**RE: REQUEST FOR FURTHER INFORMATION FOR OPERATIONAL WORKS FOR OCEAN
BREEZE ESTATE STAGE 4 AT 905L COOYA BEACH ROAD BOONIE DOON
(Your Ref. 8/10/44 (2449462))**

We refer to your Request for Further Information (RFI) dated January 18, 2010.

SCALE (AT A1 SIZE)	HOR 1:500	DRAWN	J.P.
DATE	JUNE 2011	DESIGNED	J.P.
APPROVED		CHECKED	J.P.
DWG NUMBER	1208 - C07	AMDT	A

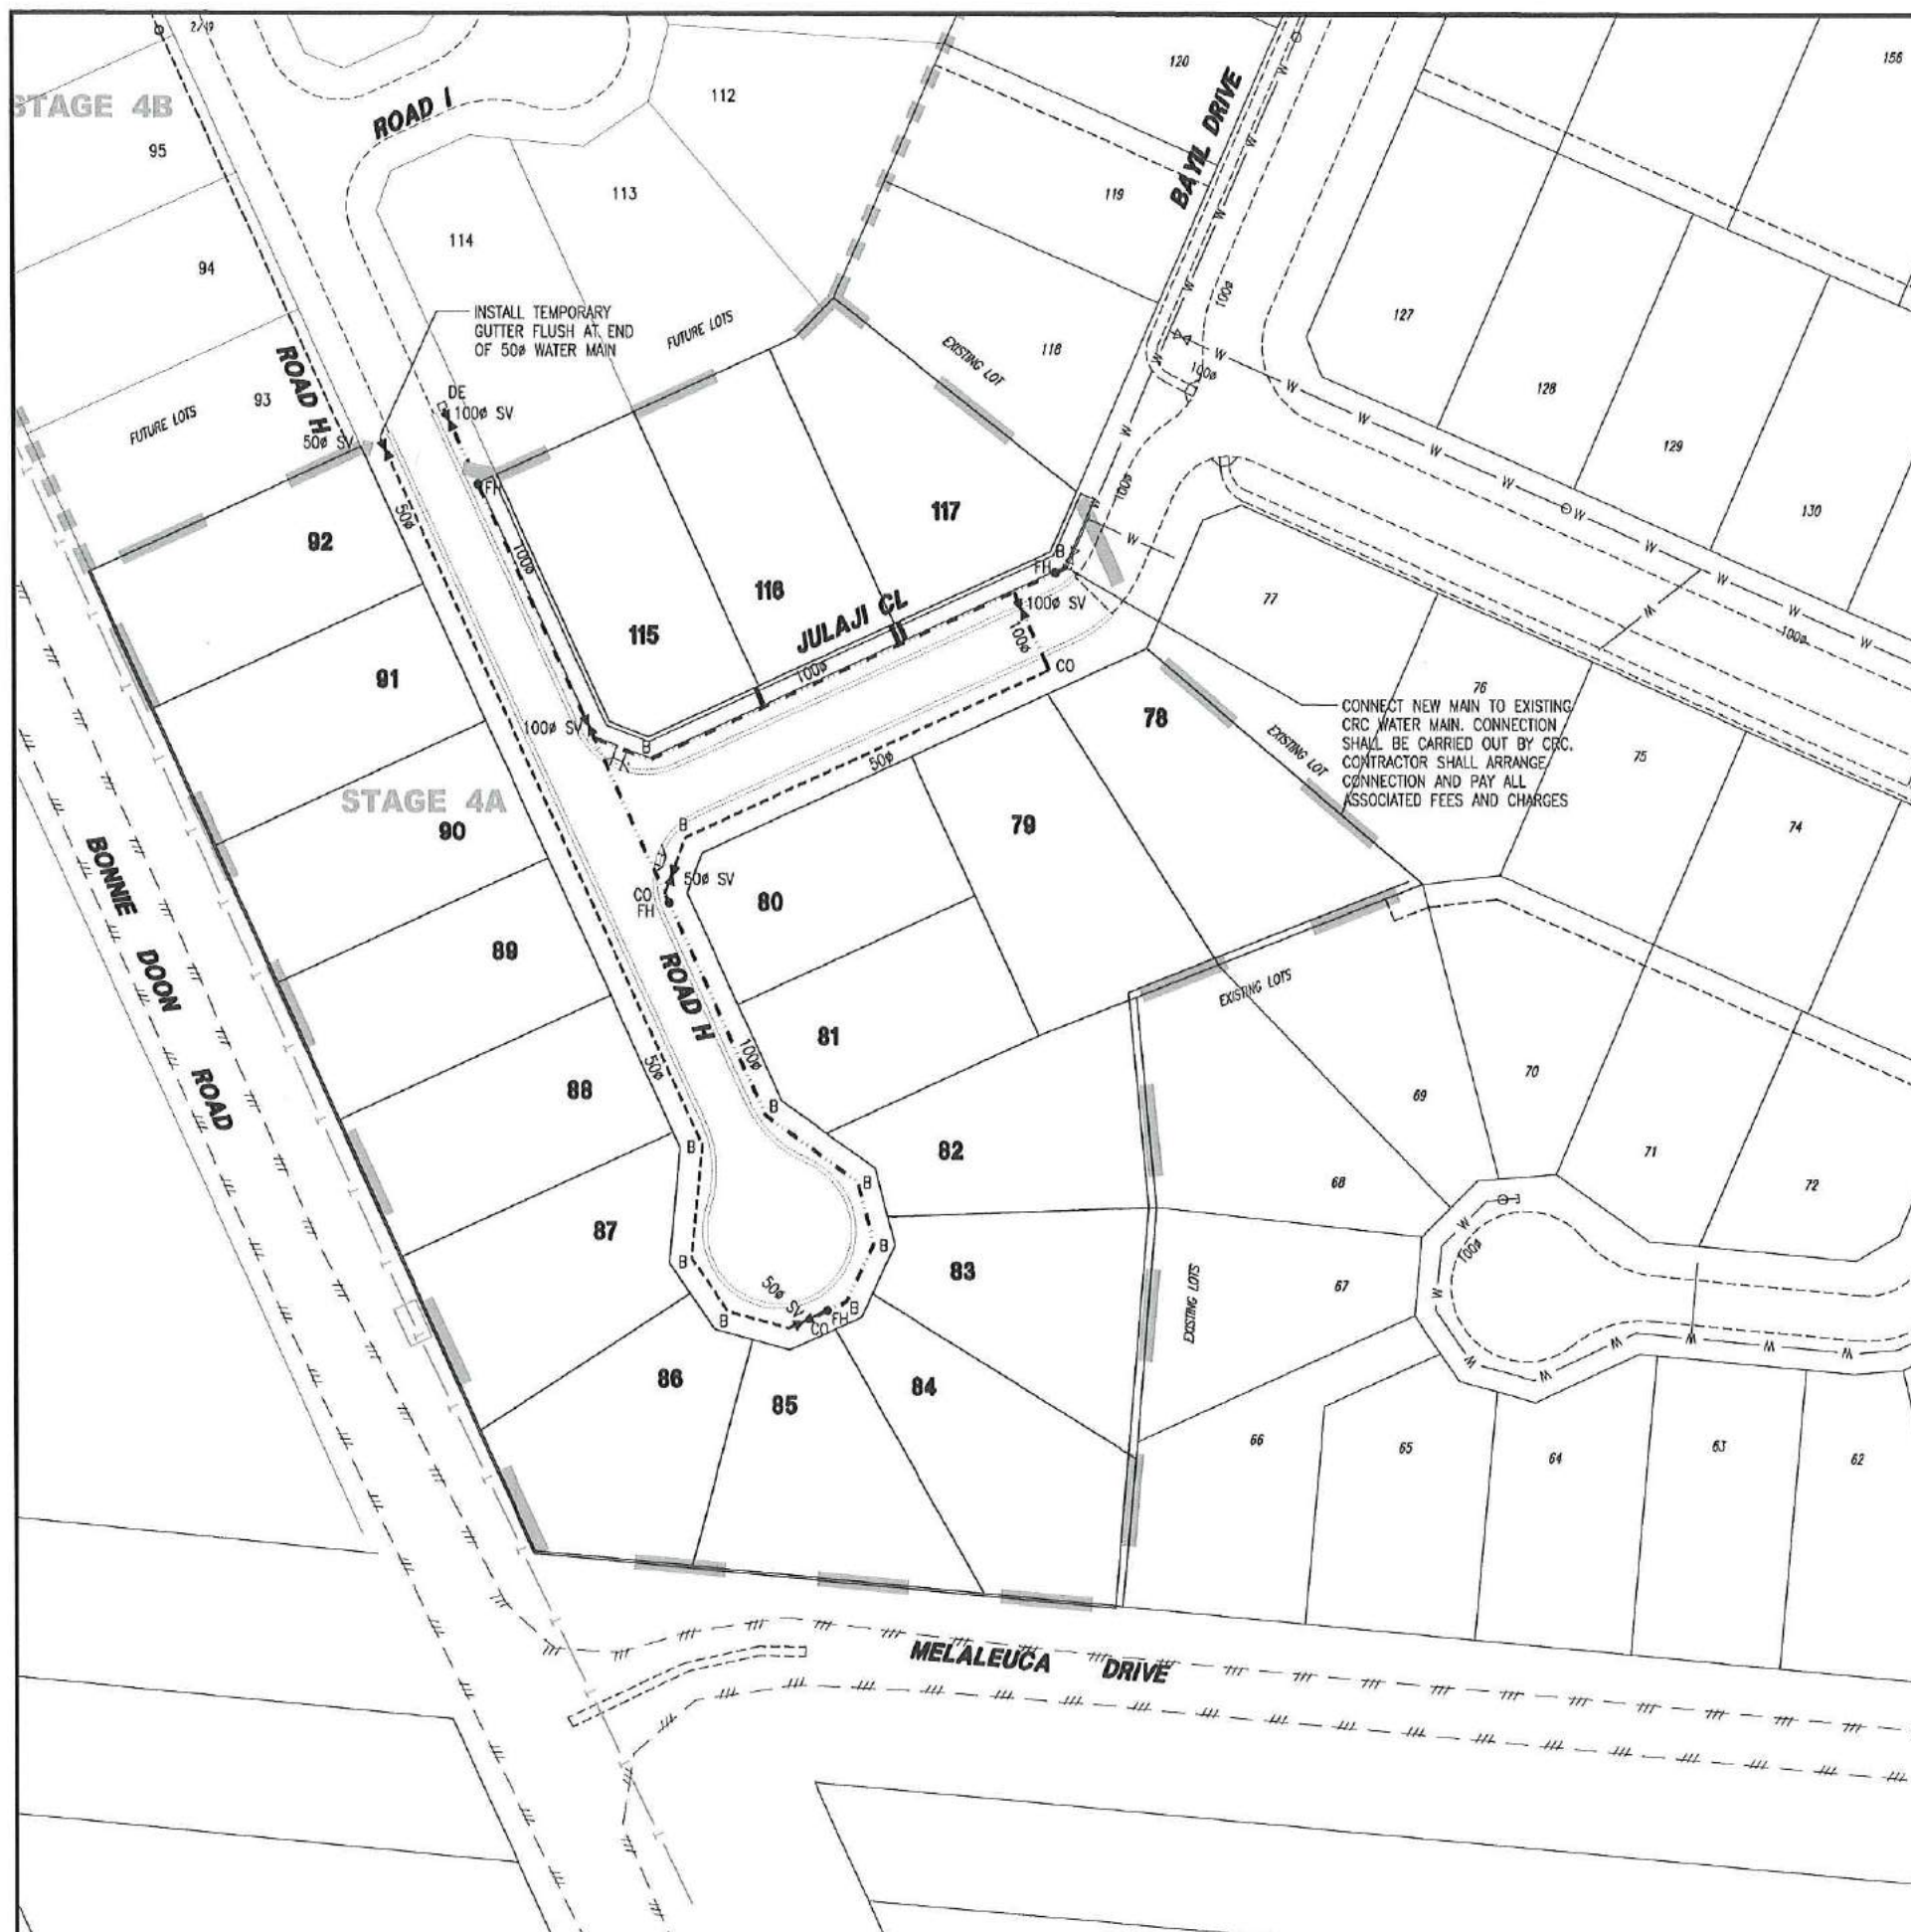
Item 7 "The proposed hydrant located in front of Lot 117 is to be relocated such that it is situated in line with the property boundary."

Item 8 "Amend Note 1, such that all water mains are on 2.8m alignments from R.P. Boundaries, in accordance with FNQROC Design Guideline Table 06.2."

We have located the fire hydrant to near the end of the existing water main so that it may be used as a flushing point. It will be close to the existing stop valve. Refer to Dwg 1208 C07

On Dwg. 1208 C07 we stipulate that the water main alignment is 2.80m from the RP Boundaries.
